PLANNING REPORT

Date: August 12, 2024
To: Noah Marlier, Esq.
From: Golda Speyer, AICP, NJPP, PMP
Applicant: Hamilton Estate

SUBJECT: CONDITIONAL USE REVIEW 204 & 228 STRAFFORD AVENUE, 18 FORREST LANE RADNOR, PENNSYLVANIA

Appendix "B" – Proposed Open Space (Annotated)

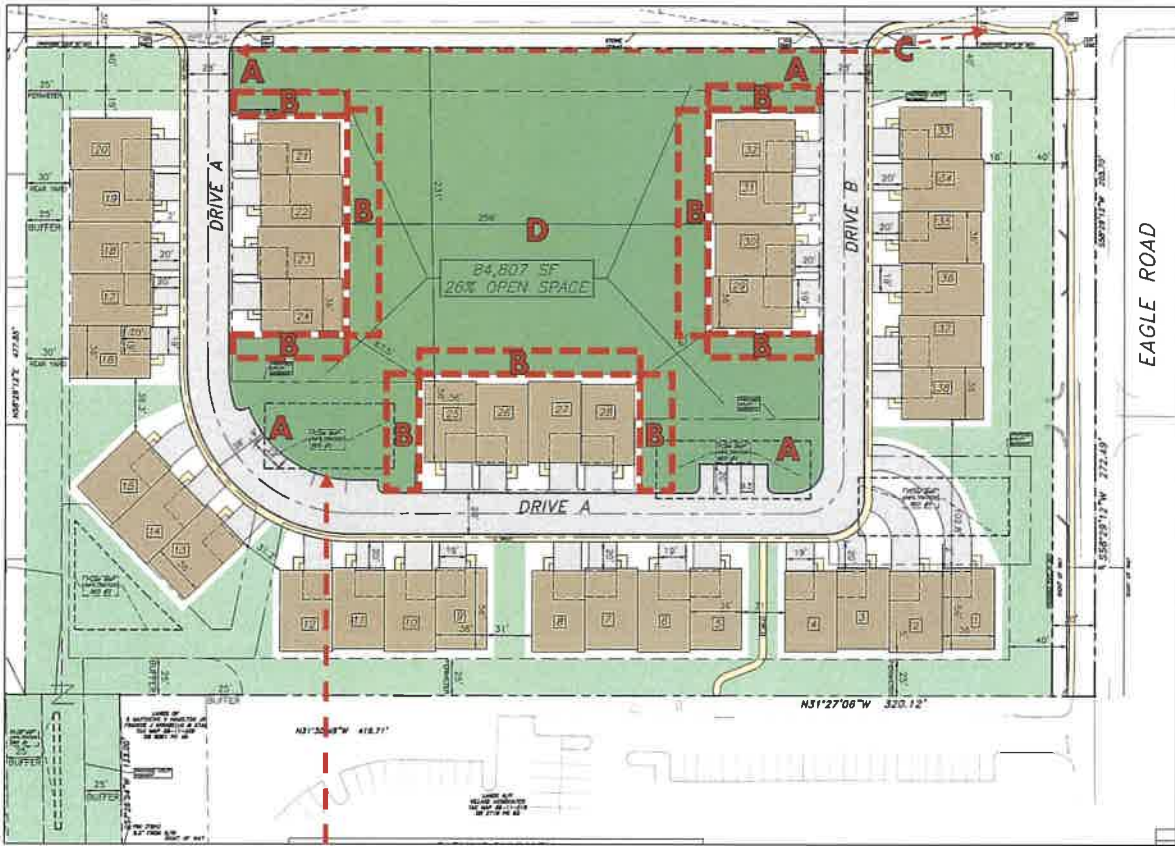
Dark green area depicted as Applicant's required open space (minimum of 25% required). Site plan depicts areas that may not meet the intent of open space requirements:

- A) Areas in between the units break the contiguous space from the main center area, which are less likely to have user activity in programming (particularly areas close to parking and Drive B).
- B) Areas include side and rear yards abutting residential units, where user activity will likely refrain from using due to privacy / proximity to resident properties.
- C) Due to property line extended to center of Stafford Ave, the 30FT property line buffer requirement commences much closer to street than ordinance may have intended.
- D) Open space overall is limited in program (1 short circler path) where likelihood of installing amenity fixtures may be unfeasible due to noise and proximity of open space to resident units. Users may likely stand back from properties and street, thus overall limiting the open space to a smaller portion of usable space.

No more than 10% of the required common open space may be used to meet the plan's stormwater management requirements. Zoning chart states 6,654 SF of open space will be dedicated to stormwater management facilities (7.9%). It should be confirmed all proposed infrastructure is depicted on site plan to confirm accurate calculation. Some SWM construction details and pipes on construction plan sets but are not depicted on site plan.
